To: Richard Collier, McKim & Creed
From: Brian Chambers, Senior Planner; 910.342.2782
CC: File;
Date: 8/3/2021
Re: Wilmington Surgcare Expansion TRC Rev. 4

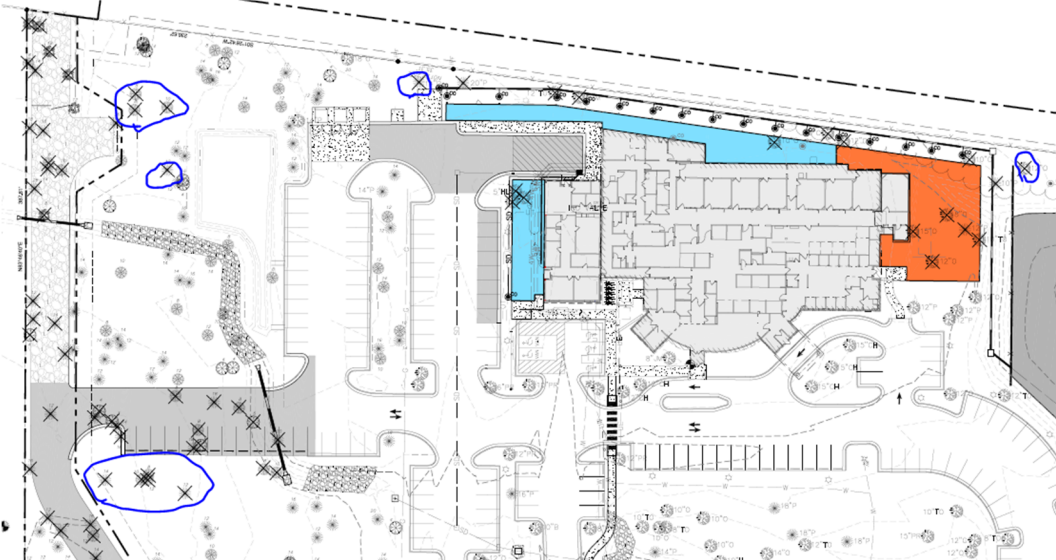
- Submit/provide copy of tree removal permit application, no permit application found in file.
- Identify trees being used to satisfy mitigation requirements. Trees that are otherwise required to be protected (required landscaping, regulated and significant trees) cannot be used to satisfy mitigation requirement.
- Retain or provide justification for the identified trees (below).
